TCEQ Interoffice Memorandum

Subject: West County Road 112 Groundwater Site (R00140), Midland, Midland
County, Texas – Addendum to the October 2009 Field Sampling Plan (FSP)

This memorandum documents the approved October 2010 Addendum No. 1 to the, "Superfund Site Discovery and Assessment Program Annual Field Sampling Plan for Sampling Drinking Water Wells – West County Road 112 Groundwater Site."

Revised Figure 1: Project Organization Chart

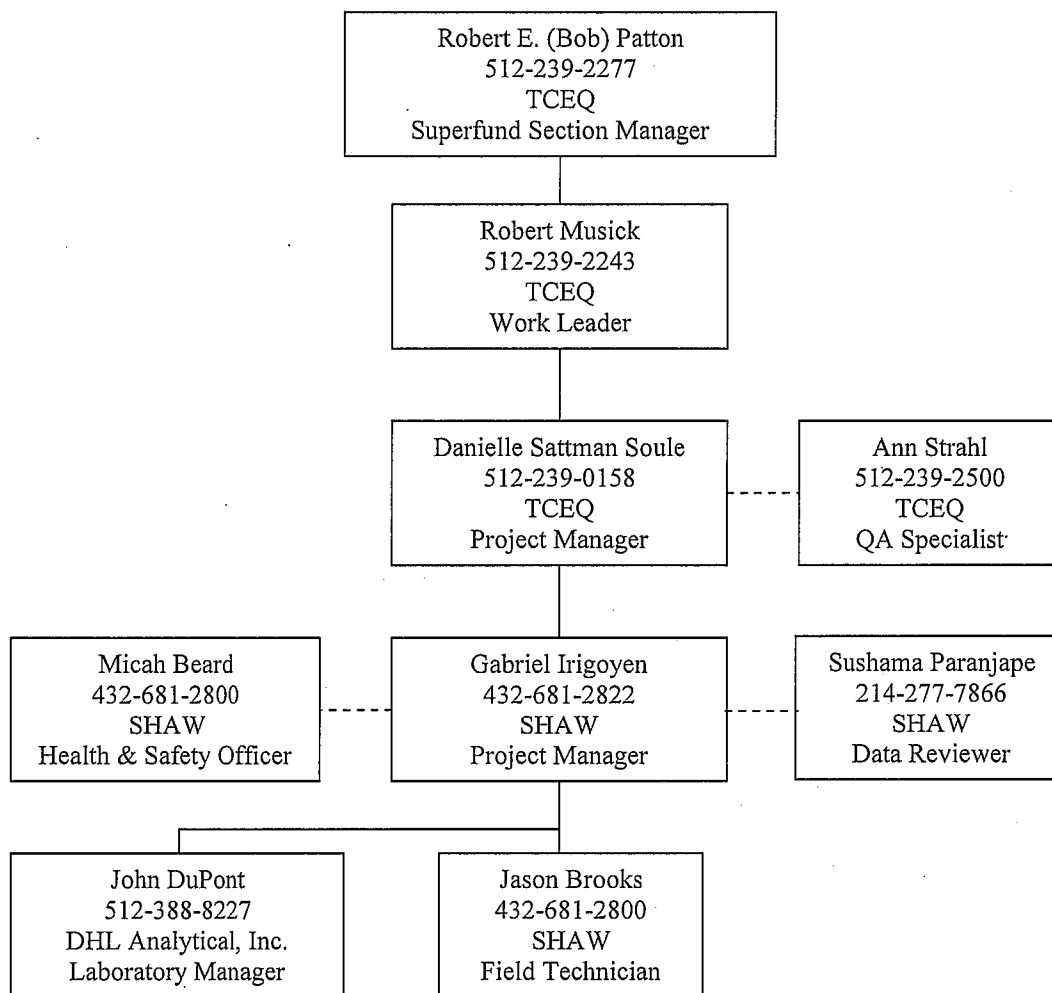
1. The Project Organization Chart has been revised to include a new QA Specialist. Revised Figure 1 is included in this memorandum.
2. **Section 2.4: Schedule of Activities** has been amended to include the following additional language:
